Technical Service Bulletin

Topic	Boot hinge access covers Flying Spur MY25
Market area	Bentley: worldwide (2WBE),China 796 VW Import Comp. Ltd (Vico), Beijing (6796)
Brand	Bentley
Transaction No.	2077175/2
Level	EH
Status	Released for publishing
Release date	Sep 24, 2025

Boot hinge access covers – To fit

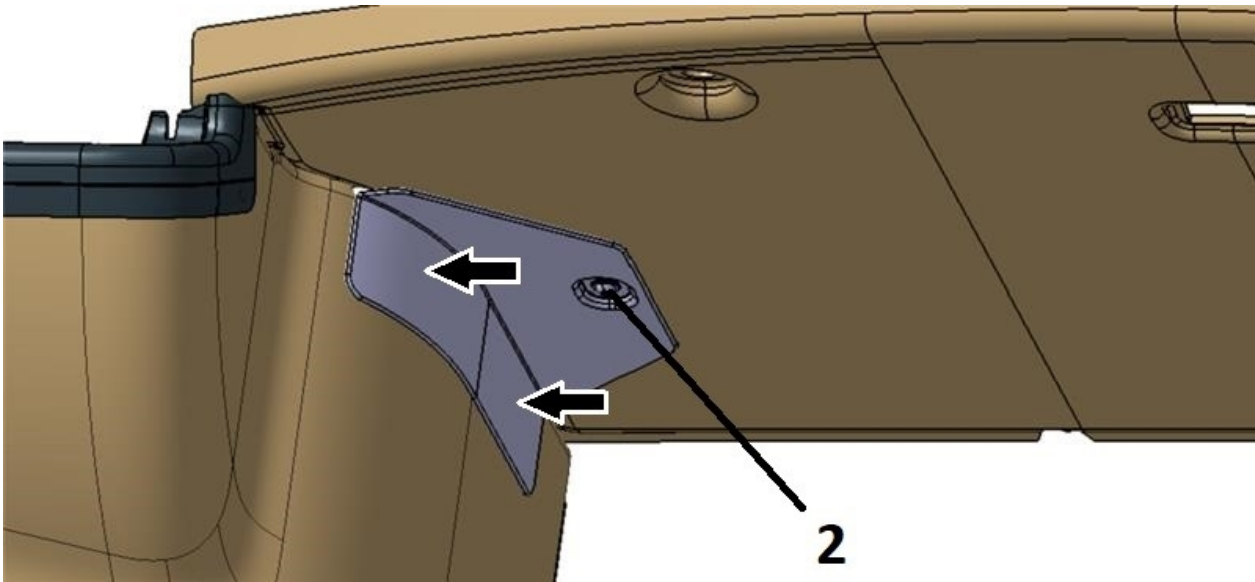
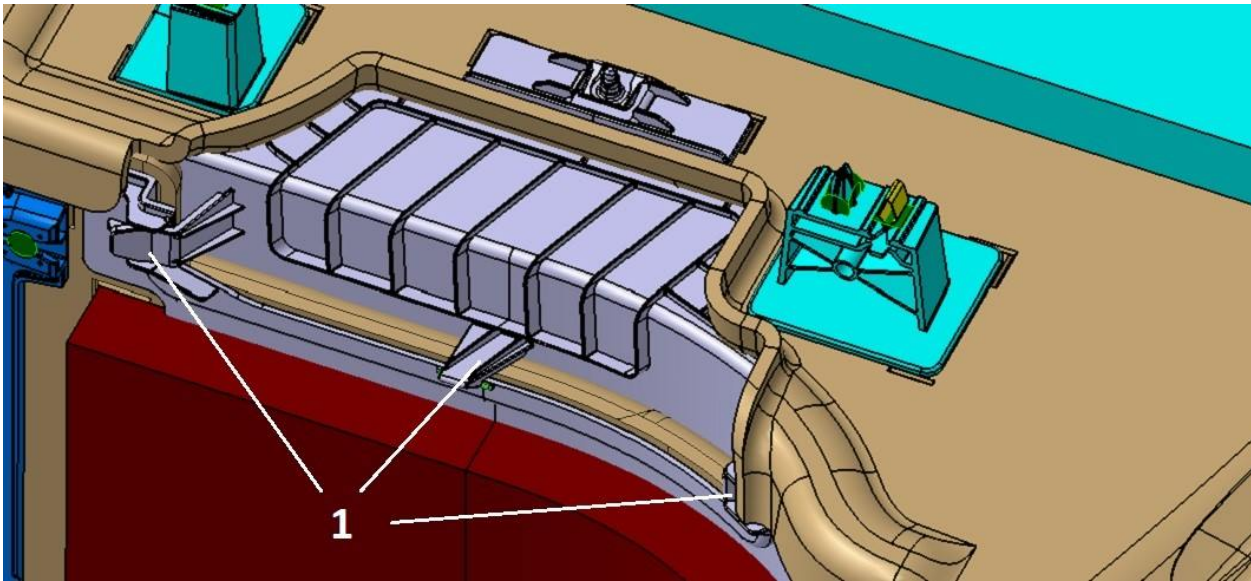
Customer complaint of exposed boot hinge area.

Customer feedback highlighted concerns about the exposed boot hinge area. Bentley has introduced boot hinge covers which are now only available to retrofit upon customer request. See solution below.

1. Align the cover with the mounting position, ensuring the clips (1) are correctly positioned.
2. Press the cover firmly until all three clips engage securely.
3. Insert the fixing screw (2) and tighten by hand to ensure proper alignment.
4. Torque the screw to 2NM.

Ensure the clips are aligned with the slots in the body before pushing in to prevent damaging the clips.
